NL-05-1362

Edwin I. Hatch Nuclear Plant
Supplement to Technical Specifications Revision Request to
Standby Liquid Control Figure 3.1.7-1

Edwin I. Hatch Nuclear Plant Supplement to Technical Specifications Revision to Standby Liquid Control Figure 3.1.7-1

Mark-Up and Published Technical Specifications Pages

Figure 3.1.7-1 (page 1 of 1)
Sodium Pentaborate Solution Volume
Versus Concentration Requirements

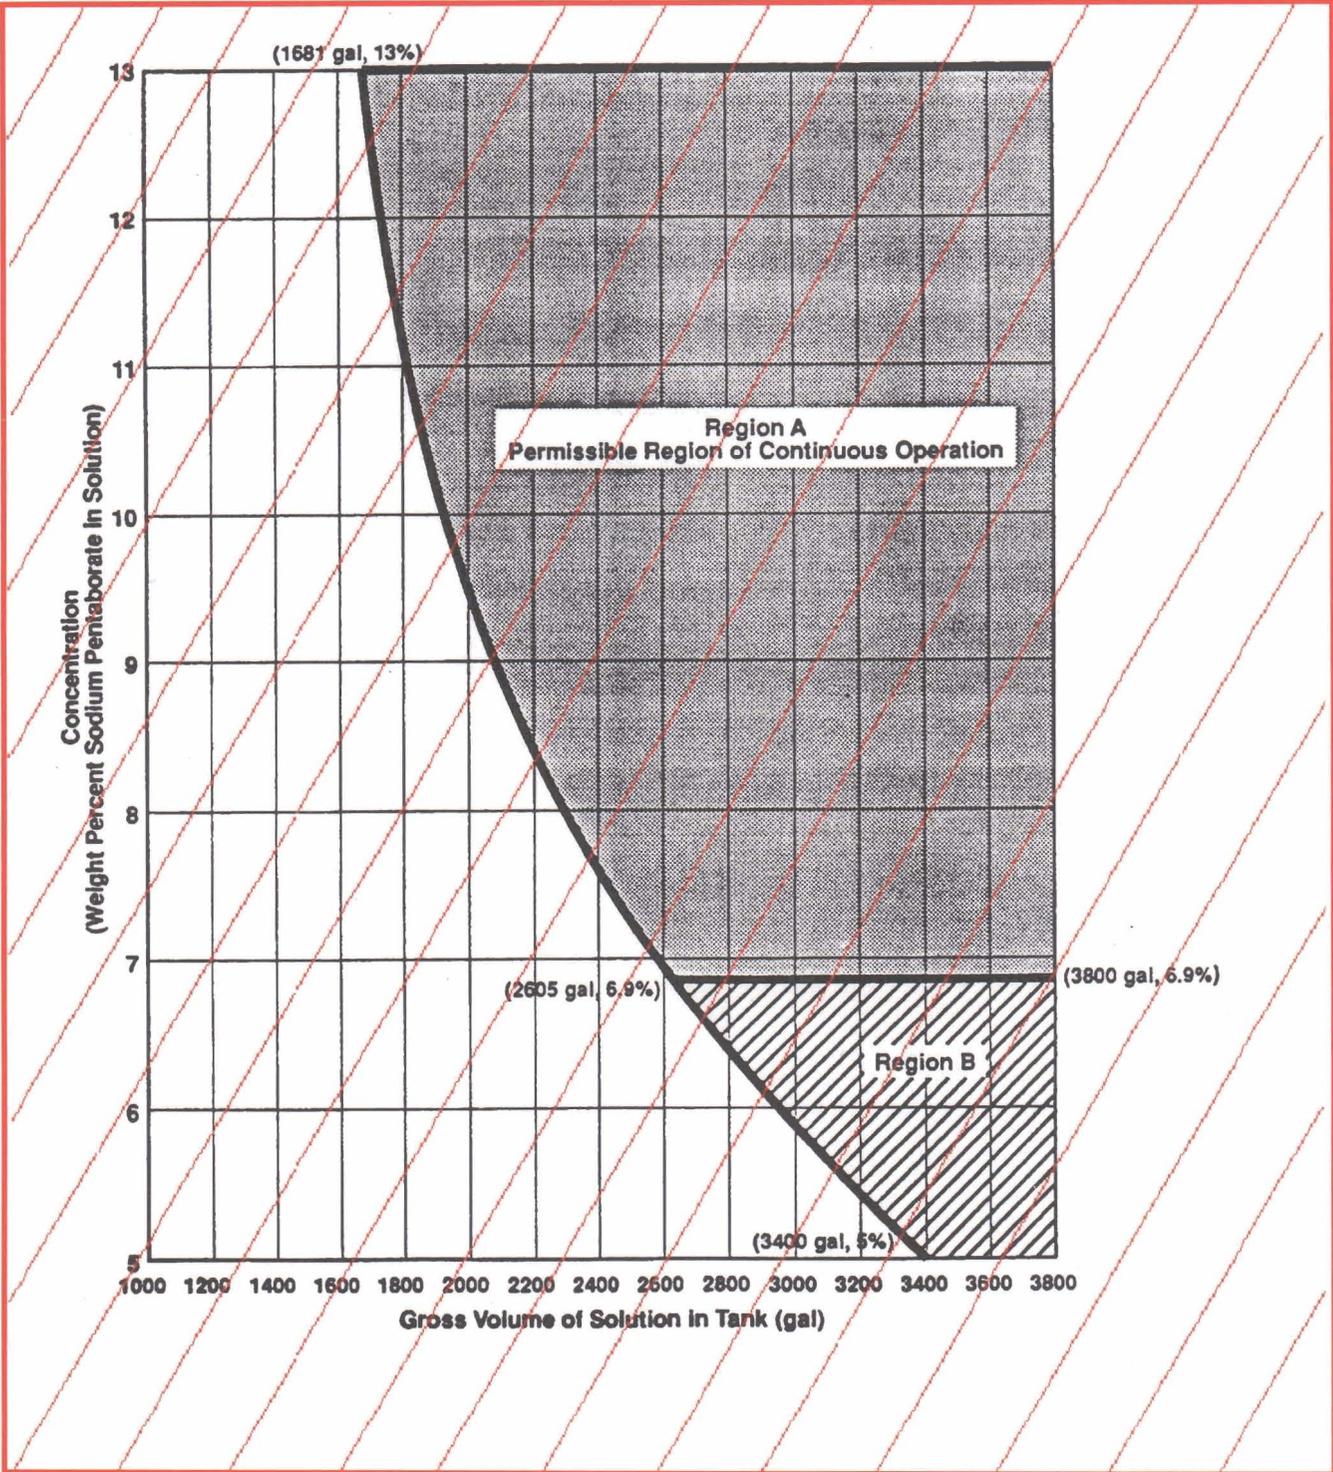
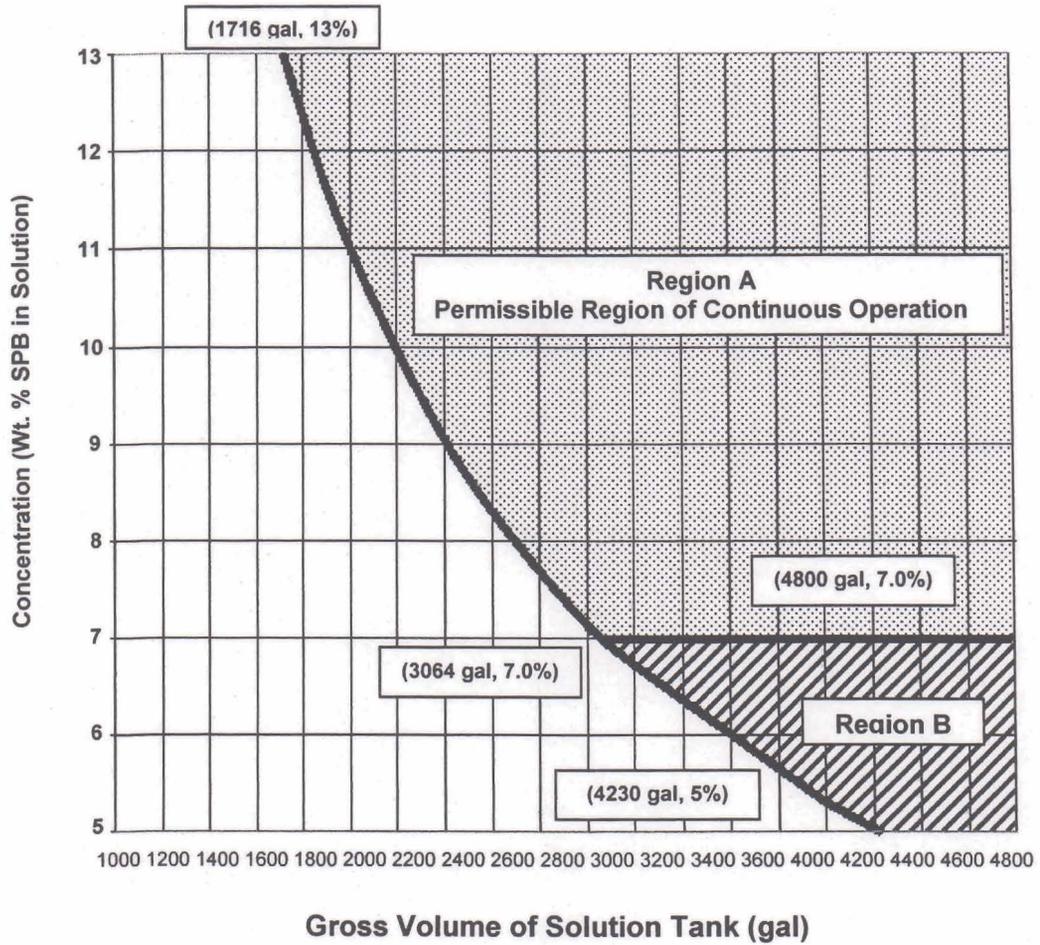
A round off inconsistency was discovered between the existing calculation of the Plant Hatch equivalency determination and the translation of that data into the current Figure 3.1.7-1. To avoid that inconsistency in the new figure, SNC is revising the proposed Figure 3.1.7-1 to increase the minimum concentration from 6.9% to 7.0%. This also represents the boundary between Region A and B. The boundary between these regions is also provided in Figure 3.1.7-2, "Sodium Pentaborate Solution Temperature versus Concentration Requirements". Consequently, Figure 3.1.7-2 is also being revised. The equivalency determination is met as follows:

The minimum concentration of Sodium Pentaborate which also represents the boundary between Region A and Region B, is changing from 6.9% to 7.0%. This increase in the concentration ensures a conservative margin to the ATWS equivalency determination required by 10 CFR 50.62.

Replace with attached figure

C = Sodium Pentaborate solution concentration (weight percent), 7.0 %.

With these numbers the equivalency determination for Hatch equals 1.01. Therefore, the change to 7.0% is acceptable.

Figure 3.1.7-2 (page 1 of 1)
Sodium Pentaborate Solution Temperature
Versus Concentration Requirements

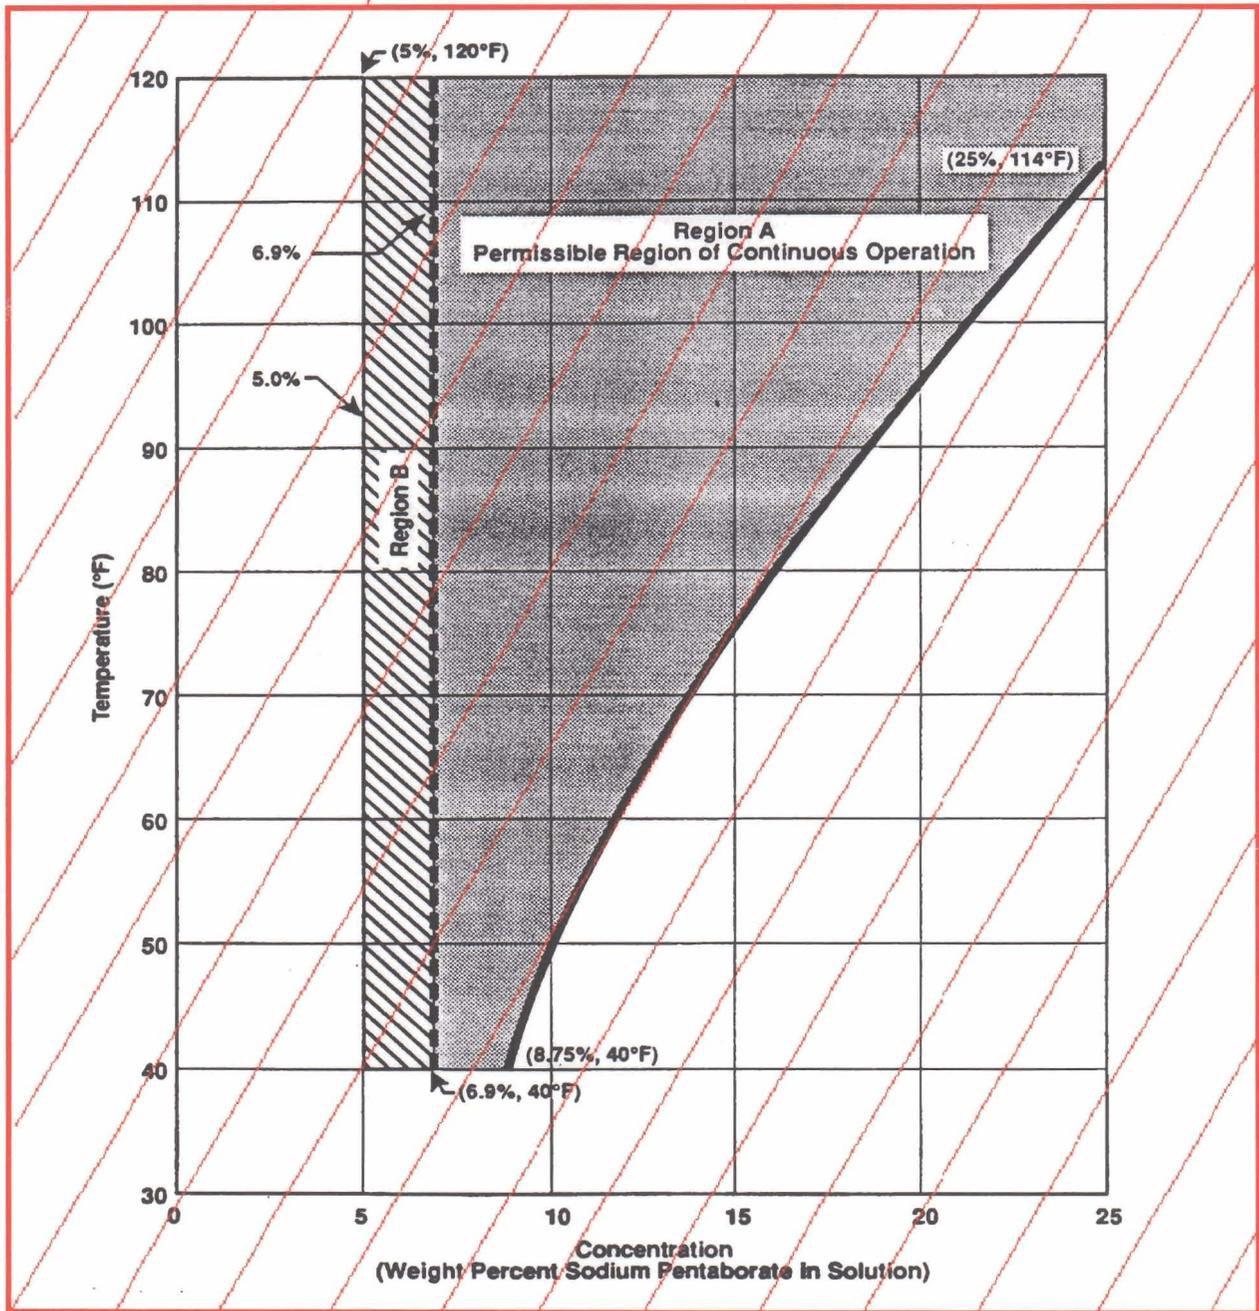
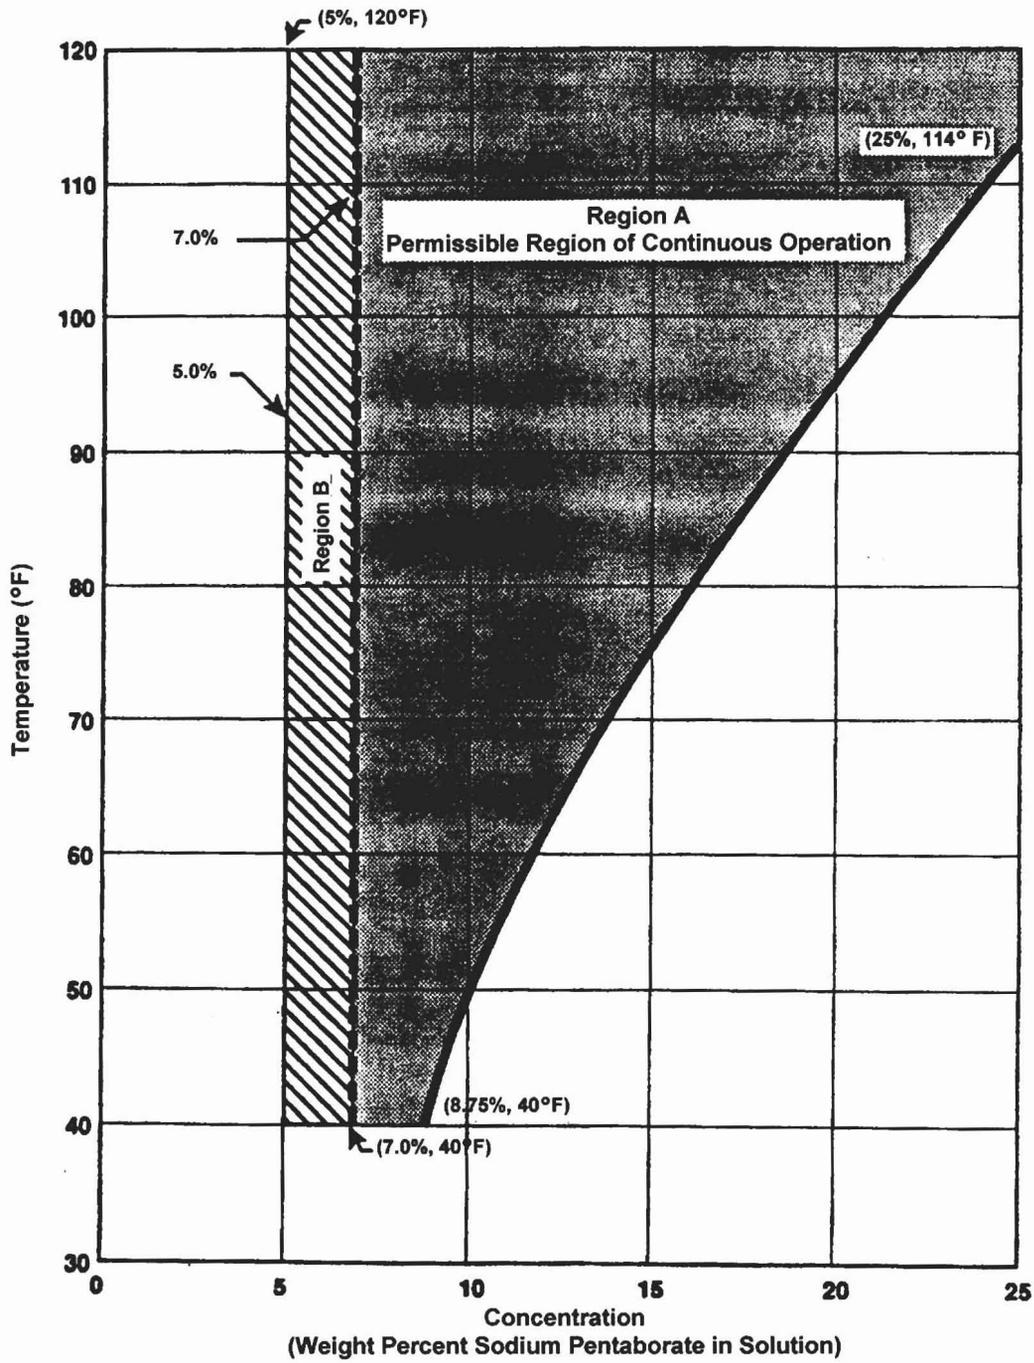
Figure 3.1.7-1 of the Units 1 and 2 Technical Specifications (TS) is being changed to reflect the increased concentration requirements of Boron-10 that must be injected into the reactor vessel, following an ATWS event, and to increase the minimum concentration of Region A from 6.9% to 7.0%. Figure 3.1.7-2, is also being changed to reflect the increase in the minimum concentration.

Replace with attached figure

Figure 3.1.7-2 (page 1 of 1)
Sodium Pentaborate Solution Temperature
Versus Concentration Requirements

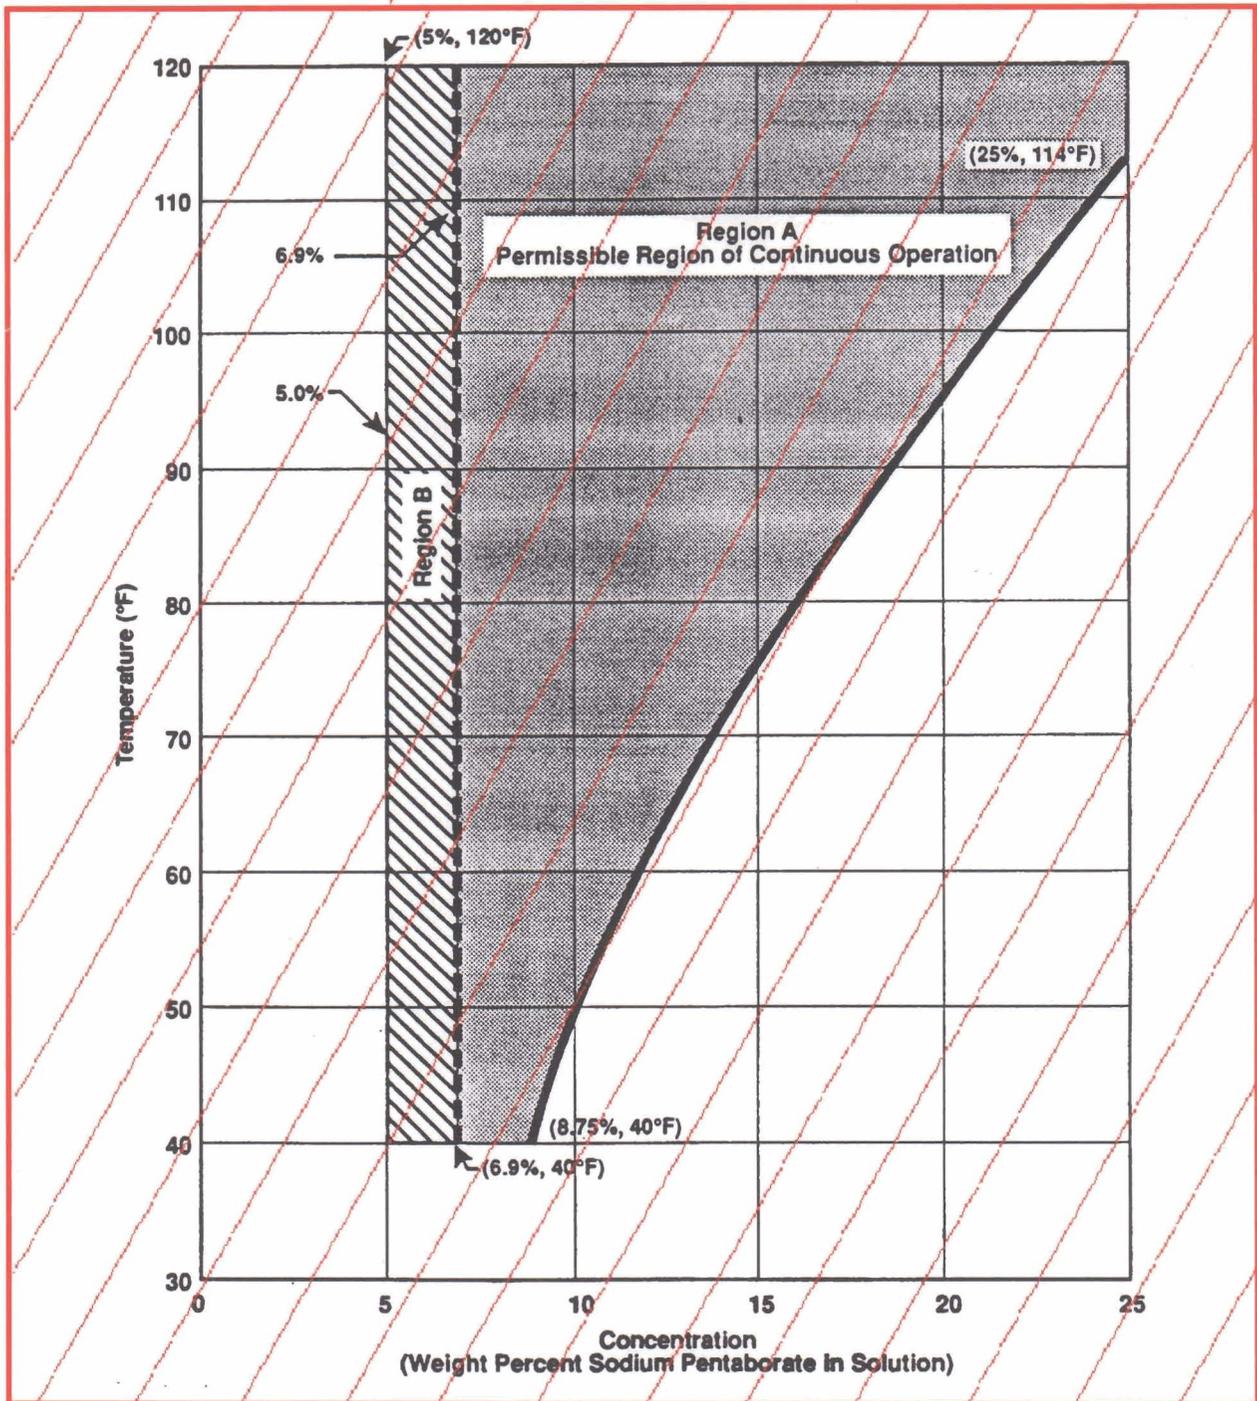
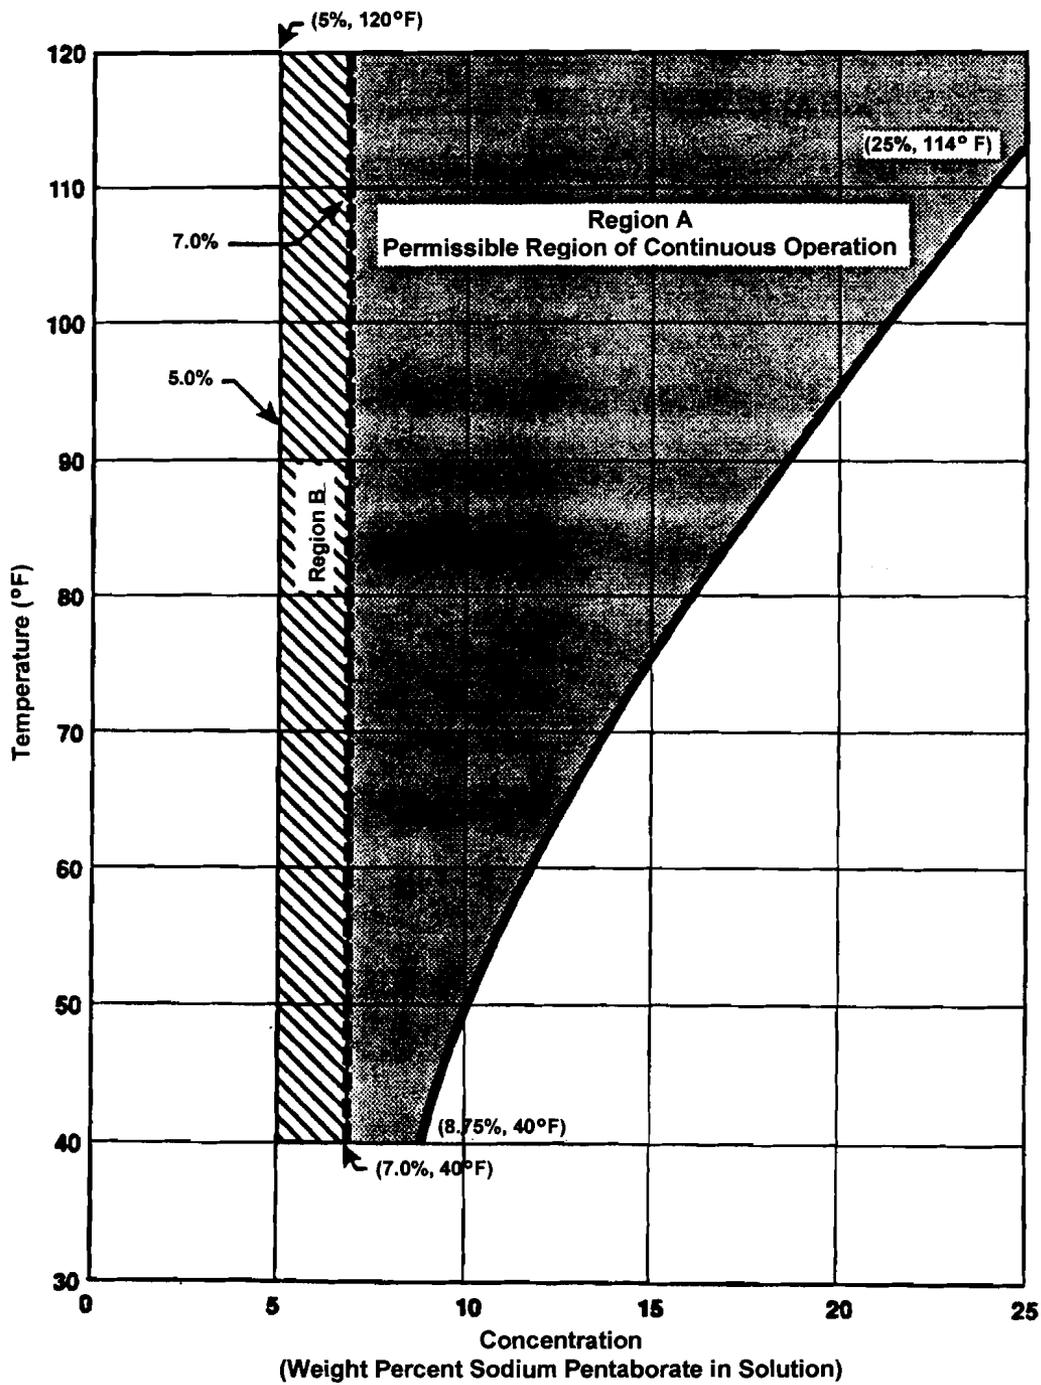
Replace with attached figure
